Technical Service Bulletin

90 ACC / HUD: set speed shown in head-up display differs from the Audi virtual cockpit

90 24 06 2074395/1 June 28, 2024.

Model(s)	Year	VIN Range	Vehicle-Specific Equipment
Q4 e-tron, and Q4 Sportback e-tron	2022 - 2024	All	Not Applicable

Figure 1. Audi virtual cockpit. **Figure 2.** Head-up display.

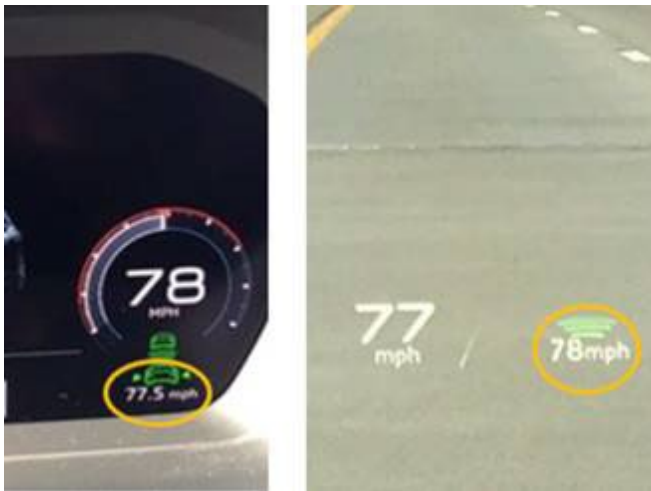
- The set speed of the adaptive cruise control is different in the head-up display (HUD) compared to the instrument cluster (Figures 1 and 2).

- The customer statement can be reproduced.
- The figure shown on the HUD is always rounded up.

Change of the display concept with software version 4141 in the Information electronics (MMI) -J794-(address word 005F).
